**ORDINARY MEETING
13 FEBRUARY 2024**

**DA/2022/1399 FOR STAGED
DEVELOPMENT: STAGE 1 ONE INTO
THREE LOT TORRENS TITLE
SUBDIVISION, TREE REMOVAL, AND
ALTERATIONS AND ADDITIONS TO
EXISTING DWELLING HOUSE
INCLUDING DEMOLITION. STAGE 2
ERECTION OF DWELLING HOUSE.
STAGE 3 ERECTION OF DWELLING
HOUSE AT 69 KENSINGTON ROAD
BOLWARRA**

**Development Plans (Under Separate
Cover)**

69 KENSINGTON RD BOLWARRA
PROPOSED RESIDENTIAL & PLAN OF SUBDIVISION
DEVELOPMENT APPLICATION

Figure 1: originally proposed demolition and tree removal plan (source: DA1.2, revision H, prepared by MM Architecture, dated May 2023)

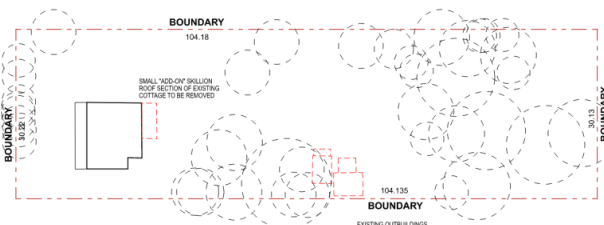
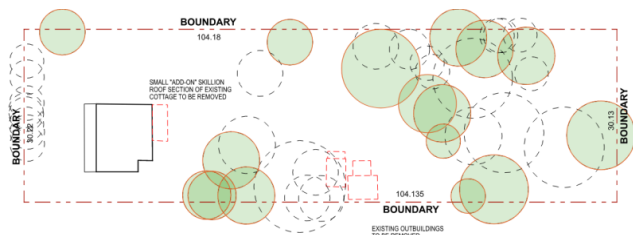
A further request for information was sent to the applicant on 21 November 2023 based on the advice received in the independent heritage review. Amended plans and documentation was provided by the applicant on 22 December 2023. A summary of the request and the response by the applicant is provided below:

Council request	Applicant response
<p>Increase retention of existing trees by implementing the following:</p> <ul style="list-style-type: none"> Consider irregular lot boundaries or an alternative subdivision form/layout that serves to retain more existing trees; Reduce the dwelling sizes and building envelopes, and consider the design of garaging / parking on site to retain more vegetation; Make alterations to incorporate an alternate driveway alignment which enables greater retention and supplementation of landscaping and screening of the additional residences located off the driveway; Remove the second driveway to incorporate landscaping in the front setback (whilst also reducing the streetscape impact of appearing as multiple dwellings from the streetscape); A general increase in landscaping to offset vegetation loss. 	<p><i>"The proposal has been amended in line with Council's comments with the primary aim to retain as many existing trees as reasonably possible. In particular, those trees that have a large canopy coverage and/or are identified as having a high retention value in the Arborist Report (AEP, 20.12.22). The amendments to the plans include:</i></p> <ul style="list-style-type: none"> <i>Removal of southern driveway in its entirety;</i> <i>Retention of existing driveway providing access to the existing and new dwellings with appropriate rights of way within the battleaxe handle</i> <i>Realignment of the driveway to curve around existing trees allowing greater tree retention and to give a more meandering look from the street;</i> <i>Subsequent amendments to the proposed lot boundaries to reflect changes to the driveway and tree retention (easements are shown in the Draft Deposited Plan and will be included in the 88b instrument);</i> <i>Rationalise the design of the new dwellings to reduce building footprint/envelopes (note building envelopes allow for covered alfresco areas);</i> <i>Removal of any previously proposed standalone structures (eg pool, bbq pavilion);</i> <i>Placement of garages to avoid tree removal where possible;</i> <i>Amendments to the landscaping scheme to focus on increased provision of trees that will provide canopy coverage (particularly within the front setback) and screening.</i> <p><i>The revised proposal allows for an additional 16 trees to be retained across the site (12 of which are moderate to high retention value). This brings the total up to 46 trees earmarked for retention across the site. This equates to 73% tree retention on site excluding the noxious weeds and hazardous trees recommended for removal by the arborist.</i></p>

Figure 2: amended demolition and tree removal plan nominating additional 16 trees for retention (source: DA1.2, revision 02, prepared by MM Architecture, dated December 2023)

Figure 4: originally proposed demolition and tree removal plan (source: DA1.2, revision H, prepared by MM Architecture, dated May 2023)

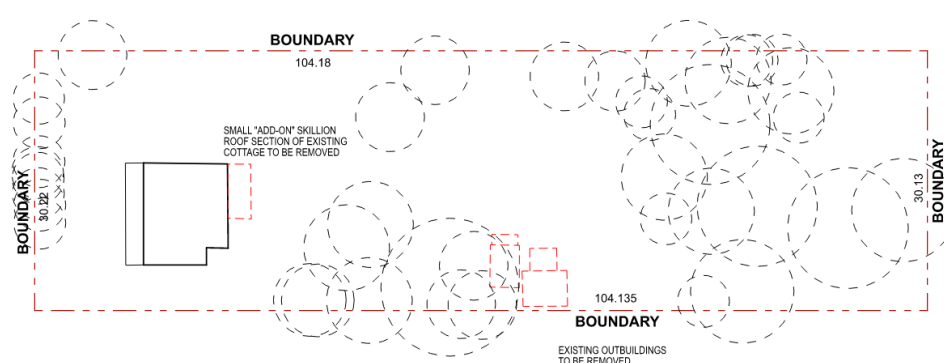
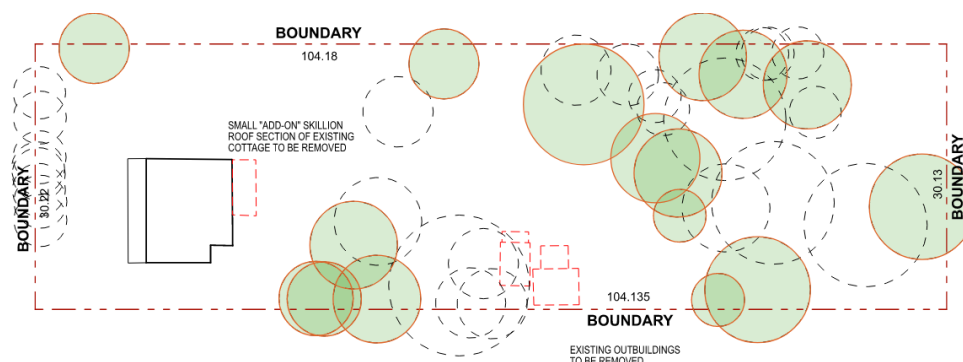
An Arborist Impact Assessment (*Anderson Environmental Planning, December 2022*) has been submitted with the application which has assessed a total of 78 trees within the subject site. Of the 78 trees, 24 were identified as native canopy or lower stratum species that are representative of the original vegetation of the area, 13 were identified as non-local native species (planted) and a further 41 were identified as planted exotic species. The original proposal was lodged requesting the removal of 47 trees across the subject site. Subsequent amendments were made, and an additional 16 trees were proposed to be retained, as represented in the below figures:

Figure 5: amended demolition and tree removal plan nominating additional 16 trees for retention (source: DA1.2, revision 02, prepared by MM Architecture, dated December 2023)
